SPECIAL COUNCIL MEETING AGENDA

Friday 15 January 2021

2 CHURCH STREET, CARRICK

Proposal: Additions & alterations to Single dwelling (Ancillary dwelling & outbuildings x2)

SCALE 1:50
 2 Church St, Carrick
 Brendan & Mel
 Shed 2

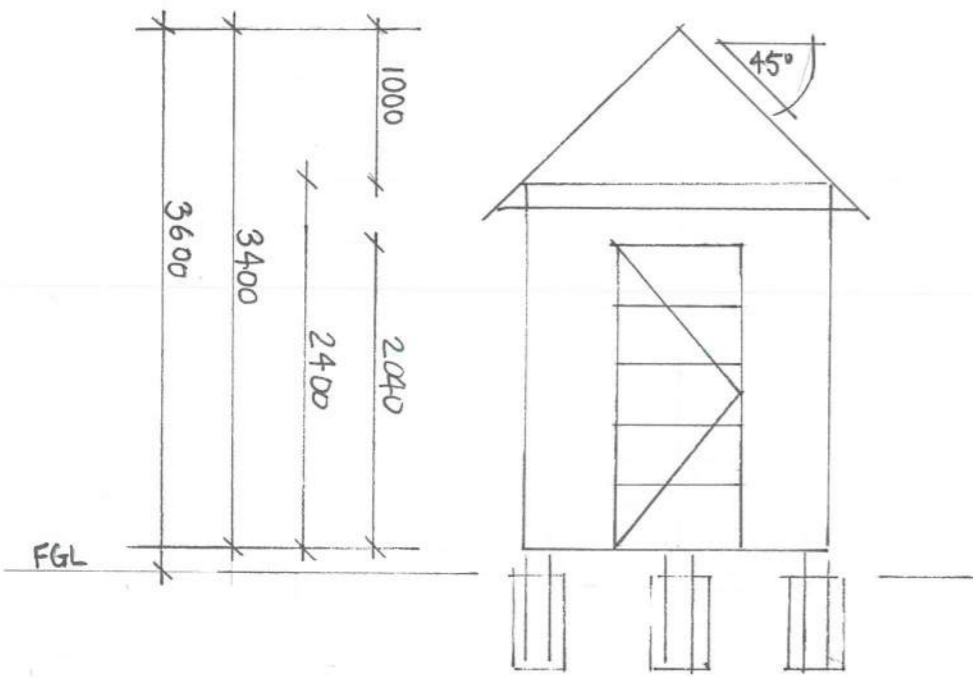
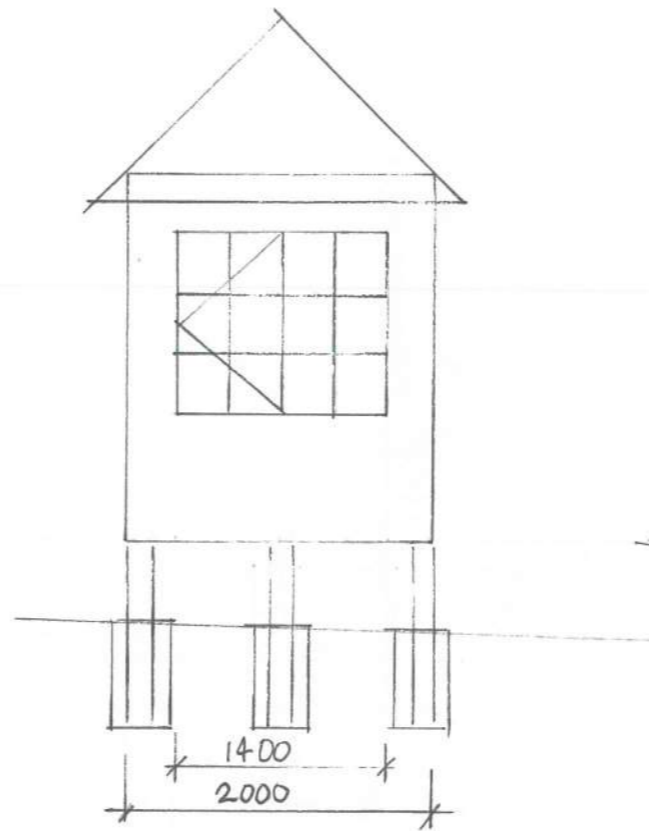
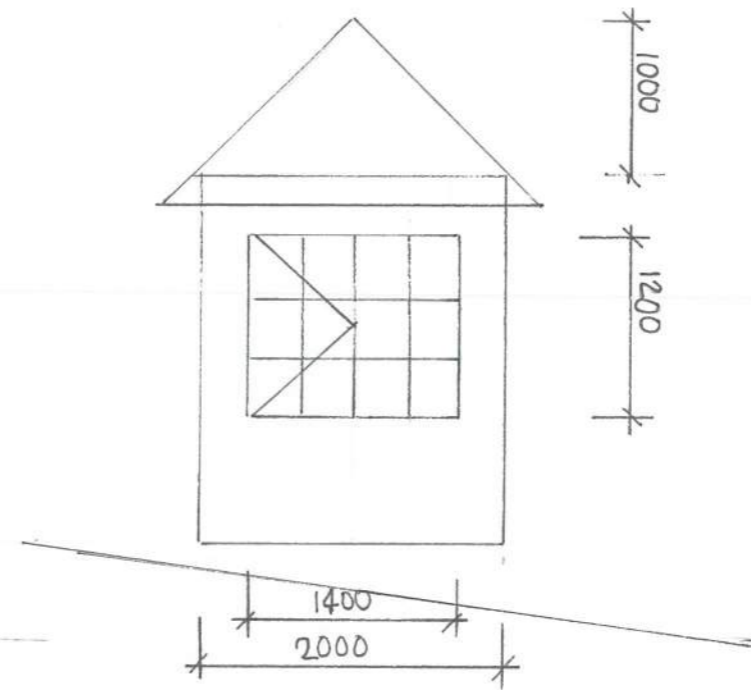
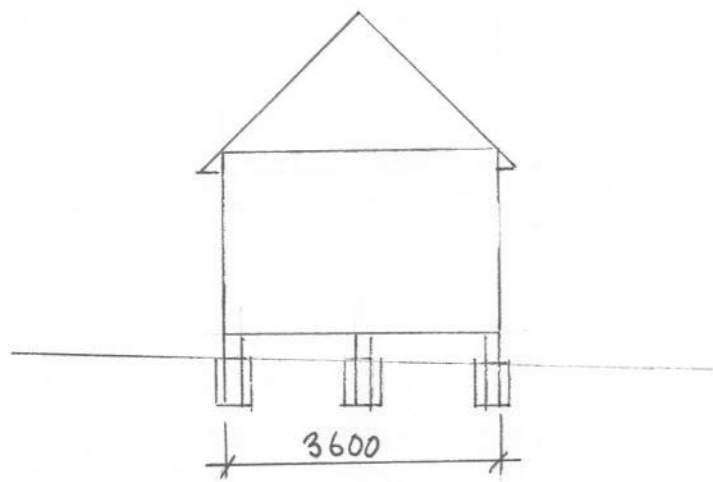
The site plan shows shed 2 located 0.6m from the frontage of Church Street and a minimum distance of 0.7m from the northern side boundary. The current location of shed 2 does not provide for consistent separation between the outbuilding and the frontage of the site. The site does not abut a road identified in Table 10.4.2.

The building known as 'shed 2' presents a privacy concern for us as some of the windows overlook our main bedroom and our children's outdoor play area. We do not feel these windows are required in a building proposed to be a garden shed. This building also adds to the increased density of this property. The location of this is justified as a 'windbreak' due to trees that were removed. The shrubbery that was removed were 'weeds' and in order to reduce environmental impact and improve the landscape a more appropriate windbreak would have been to replace the shrubbery with a more appropriate choice of plant. This would have improved both our and their outlook while acting as a windbreak, not impacted our privacy and had less impact on the environment.

- a) **Shed 2 to be located a minimum distance of 4.5m from the front boundary and a minimum distance of 4m from the rear boundary.**
 - b) **The areas of the existing garage to be used for the purpose of an ancillary dwelling clearly shown with a total floor area of 60m² or less. The area/s to be used for residential storage must be shown on the floor plan.**

The amended plan will need to show shed 2 located behind the façade of the existing dwelling and a minimum distance of 4m from the rear boundary. The relocation of shed 2 will ensure the setback to the frontage is compatible with the pattern of development in the surrounding area, consistent with the objective of the clause.

SCALE 1:100
 2 Church St, Carrick
 Brendan & Mel
 Shed 1

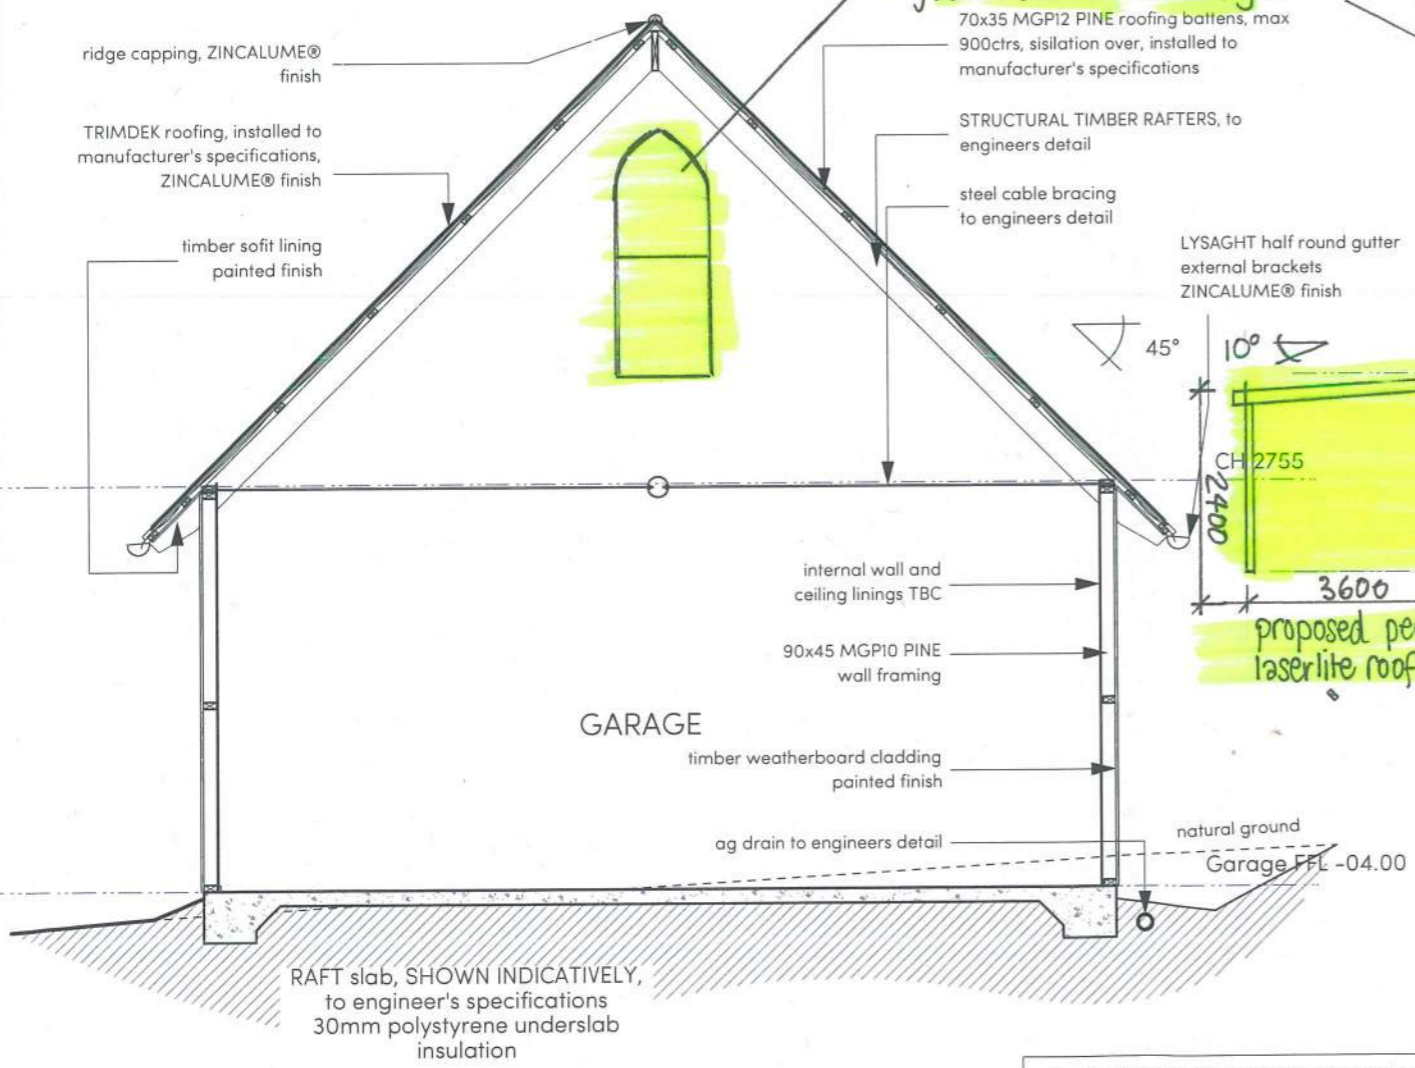
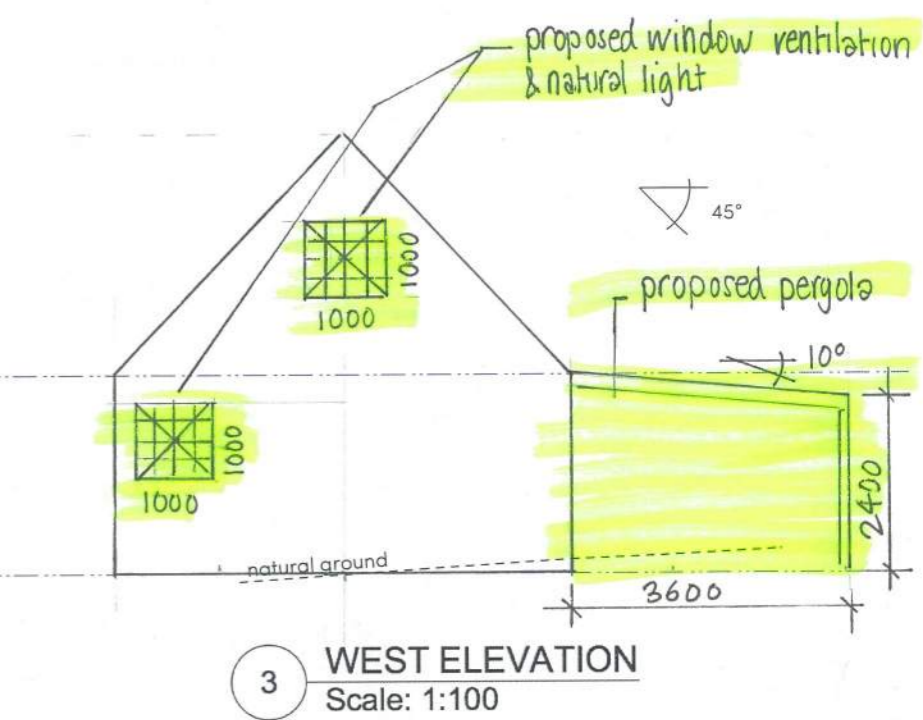
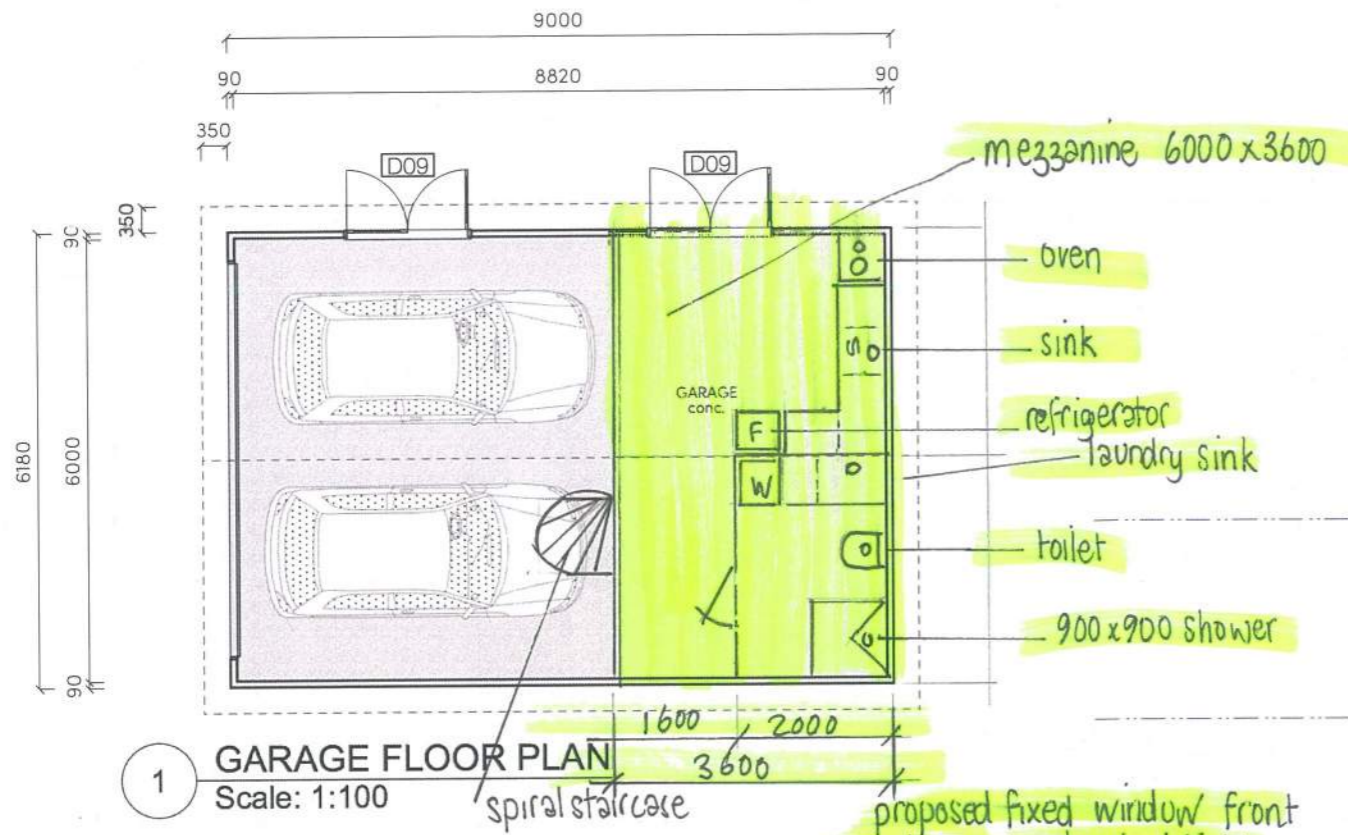
| <p>Concern - Plans show a height for 'shed 1' of 4.4m above FGL – however our</p> |

| <p>measurements show it to more like 5m. The height and proximity to the boundary is questioned.</p> |

Shed 1 shown on the site plan is located 1.5m from the rear boundary and has a maximum height of 4.4m. The proposed outbuilding is not expected to cause overshadowing of private open space of the dwelling to the east. Due to the location of windows in the adjoining dwelling, no reduction in sunlight to a habitable room is expected.

| <p>Comment: The plans show a maximum height of 4.4m above ground level and a rear boundary setback of 1.5m.</p> |
